Access Compliance Report

Public Rights-of-Way

Intersection ID: 46498	Main Street: BALTRAY_RD	Cross Street: KELSO_CT	Location: NW
ADA ID: 736BE7A98CAC	Ramp Type: PerpDiag	Initial Pass/Fail: Fail	Overall Compliance: No
		Severity Score: 22.5

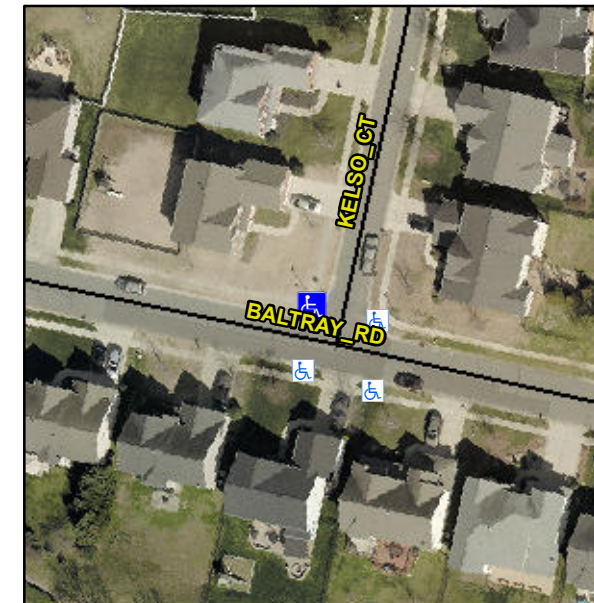
Not Found, R304.5.1, R304.2.2, R304.5.3

Compliance	Description	Data	Compliance	Description	Data
N/A	Ramp Length (in)	50.0	No	Ramp Slope (%)	9.7
No	Ramp Width (in)	45.5	No	Ramp XSlope (%)	3.1
N/A	Flare Type LT	N/A	N/A	Flare Type RT	N/A
N/A	Flare Slope LT (%)	N/A	N/A	Flare Slope RT (%)	N/A
N/A	Flare Traversable LT?	N/A	N/A	Flare Traversable RT?	N/A
N/A	Landing Length (in)	N/A	N/A	DWS Provided?	N/A
N/A	Landing Width (in)	N/A	N/A	DWS Contrast?	N/A
N/A	Landing Slope (%)	N/A	N/A	DWS Length (in)	N/A
N/A	Landing X Slope (%)	N/A	N/A	DWS Full Width?	N/A
N/A	Landing Curb? (Y/N)	N/A	N/A	DWS Offset (in)	N/A
N/A	Shared Landing?	N/A			
N/A	Gutter Ponding?	N/A	N/A	Gutter Slope (%)	N/A
N/A	Gutter Lip Ht (in)	N/A	N/A	Gutter X Slope (%)	N/A
N/A	Painted X Walk1?	No	N/A	Painted X Walk2?	No
	X Walk 1 Direction	To SW		X Walk 2 Direction	To SE
N/A	X Walk 1 Width (in)	N/A	N/A	X Walk 2 Width (in)	N/A
	X Walk 1 Slope (%)	1.4		X Walk 2 Slope (%)	0.2
	X Walk 1 X Slope (%)	1.2		X Walk 2 X Slope (%)	2.0

Remove & Replace Curb Ramp With Two New Directional Ramps or Equivalent.
